Proposal #22: 1176-02-69, WISC 2020 079
Tomahawk - Minocqua
Wisconsin River Bridge B-35-0063
USH 51
Lincoln County

1176-02-79, WISC 2020 080
Minocqua - Tomahawk
CTH S to USH 8, SB
USH 51
Lincoln County

This is Addendum No. 03, which provides for the following:

ADDENDUM NO. 03

Addendum No. 03
ID 1176-02-69
Revised Sheet 131
March 5, 2020

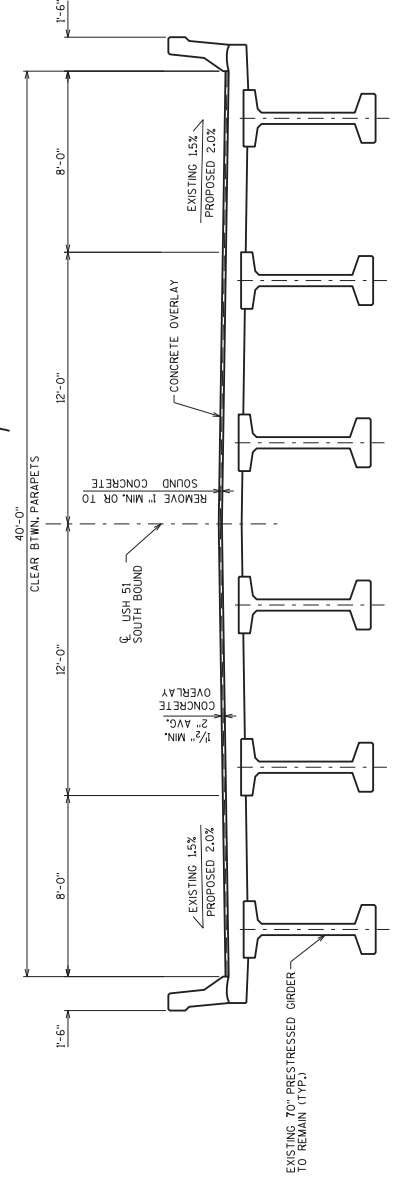
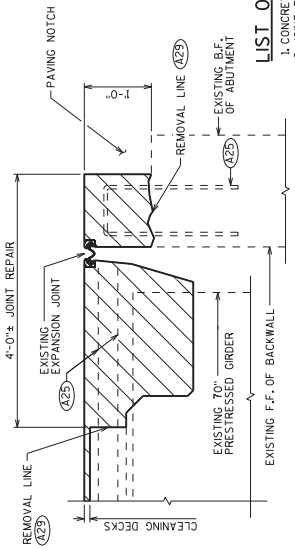
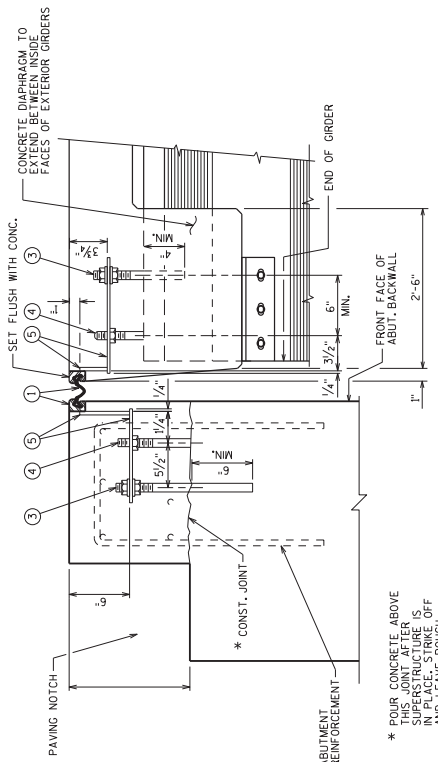
NO. DATE REVISION BY
A 3/5/2020 BID ITEM UNIT CHANGE JLR

EXPANSION DEVICE
SHEET 4
134

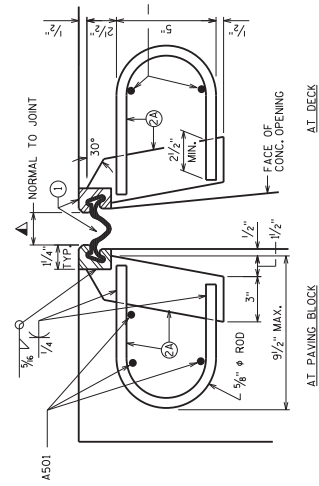
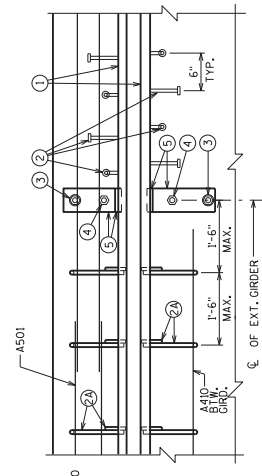
51	Miscellaneous Quantities, sheet 51 In the <i>Concrete Barrier Temporary Precast</i> quantity table, edited quantities for the following pay items: 603.8000 Concrete barrier Temporary Precast Delivered; 603.8125 Concrete barrier Temporary Precast installed; and 614.0905 Crash Cushions Temporary.
57A	Miscellaneous Quantities, sheet 57A (from Addendum 1) Added the pay item 211.0500 Prepare Foundation For Base Aggregate to the <i>Removing Pavement</i> MQ table
131	Structure Plan B-35-63 Revised unit of measurement for pay item 509.1500 Concrete Surface Repair (unit was SY, unit revised to SF)(the previous quantity remains unaltered)
134	Structure Plan B-35-63 Revisions concerning the expansion device

NO.	DATE	TEMPERATURE TABLE	REVISION	BY
1	3/5/2020			JLR

30. Expansion Device, B-35-63.

This special provision describes furnishing and installing an expansion device as the plans show conforming to standard spec 502 as modified in this special provision.

The minimum thickness of the polychloroprene strip seal shall be 1/4 inch for non-reinforced elastomeric glands and 1/8 inch for reinforced glands. Furnish the strip seal gland in lengths suitable for a continuous one-piece installation at each individual expansion joint location. Provide preformed polychloroprene strip seals that conform to the requirements ASTM D3542, and have the following physical properties:

SHADED UNDERSIDE DECK TEMP. (°F)	SOUTH ABUTMENT JOINT OPENING (NORMAL TO J.L.)	NORTH ABUTMENT JOINT OPENING (NORMAL TO J.L.)
85°	1 3/4"	2"
75°	2 1/8"	2 3/8"
65°	2 7/8"	2 7/8"
55°	3 1/4"	3 1/4"
45°	3 7/8"	3 7/8"
35°	4 1/4"	4 1/4"
25°	4 7/8"	4 7/8"
15°	4 3/4"	4 3/4"
5°	4 3/4"	4 3/4"

A SMALL JOINT OPENING DUE TO A HIGH TEMPERATURE AT TIME OF FABRICATION MAY REQUIRE NEOPRENE STRIP SEAL INSTALLATION INTO STEEL EXTRUSIONS PRIOR TO SETTING THE EXPANSION JOINT.
